## SIB 64 10 19

## SERVICE ACTION: OPTIMIZING THE WATER DRAIN

E-Series	Model Description	Production Date
F25	X3 Sports Activity Vehicle	By VIN list
F26	X4 Sports Activity Coupe

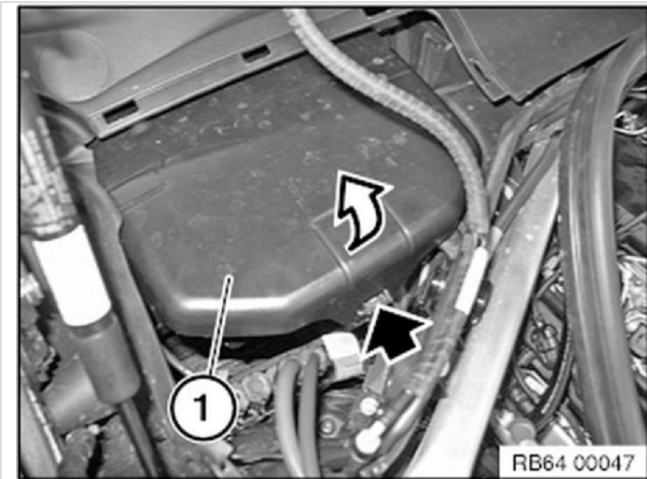
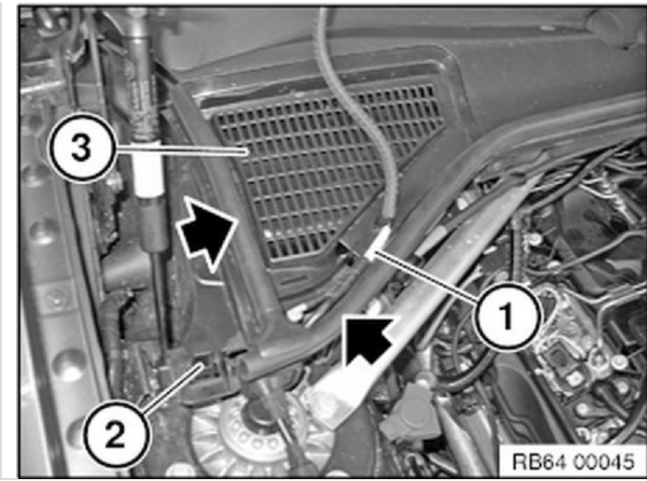
- Lack of a cowl drainage shaft cover
- Lid on the ventilation microfilter housing lacks water drainage channels (only on vehicles prior to July 2013 production)

- Install the drainage shaft cover on all vehicles
- Replace the earlier style, smooth microfilter lid (vehicles produced prior to July 2013) with the later style that incorporates drainage channels

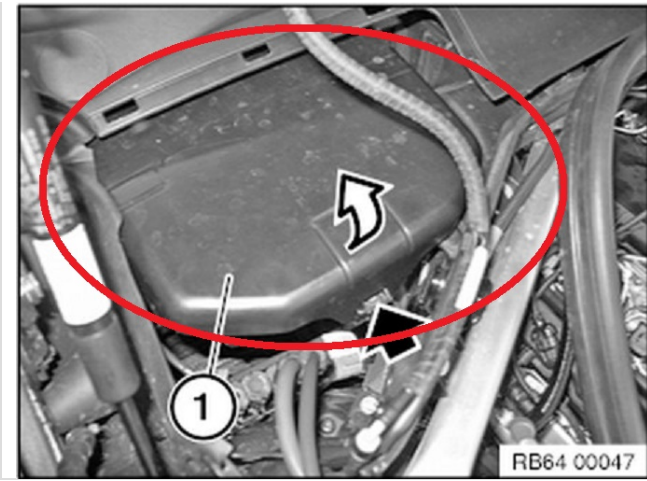
**NO**-This is a smooth filter box lid which was installed prior to July 2013 production.

**Replace this style lid.**

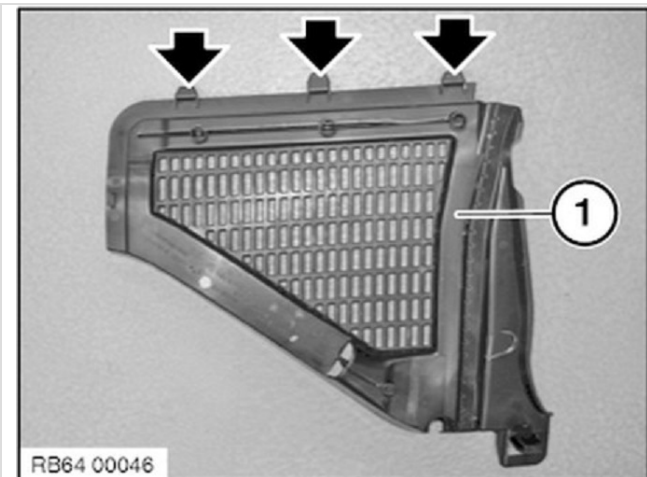
- Install the drainage shaft cover (marked in red) onto the filter frame
- Reassemble vehicle

Note: The tabs (arrows) on the cover (1) must engage correctly under the cowl panel.
